CLASS III SERVICE INSTRUCTIONS

No. 1035
ATA Code 33-40

SUBJECT: LIGHTS - INSTALLATION OF A MOUNTING PLATE FOR WING TIP MOUNTED NAV AND STROBE LIGHT ASSEMBLIES

Service Instructions No. 1035

Figure 1. All 19, 23 and 24 Series Airplanes.

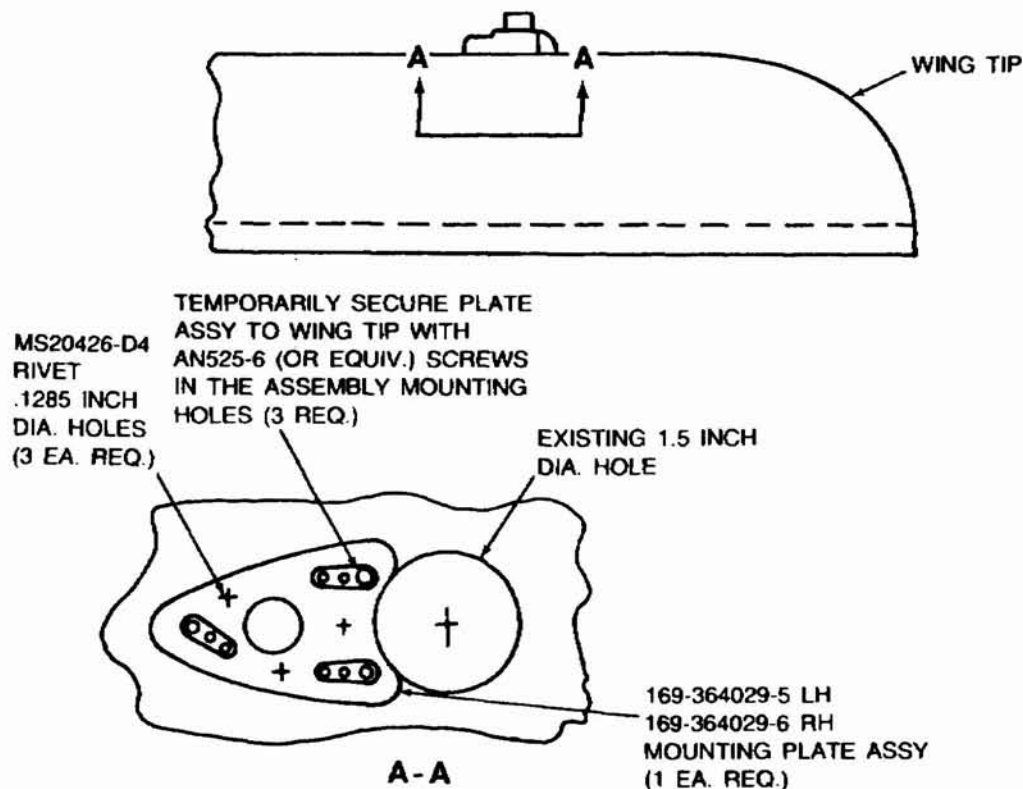
3. Position the applicable new (see MATERIAL for correct part number) mounting plate assembly over the nav/strobe light opening inside the wing tip and temporarily secure the plate assembly to the wing tip with AN525-6 (or equivalent) screws in the light assembly mounting holes. (See figure 1 or figure 2 as applicable.)

4. Using a No. 30 (.1285 inch diameter) drill bit, back drill the mounting holes for the plate assembly through the wing tip from the pre-drilled holes in the plate assembly.

5. Countersink the holes drilled in step 4 on the outside surface of the wing tip and

install the mounting plate assembly in the wing tip with MS20426AD4 rivets of the appropriate length.
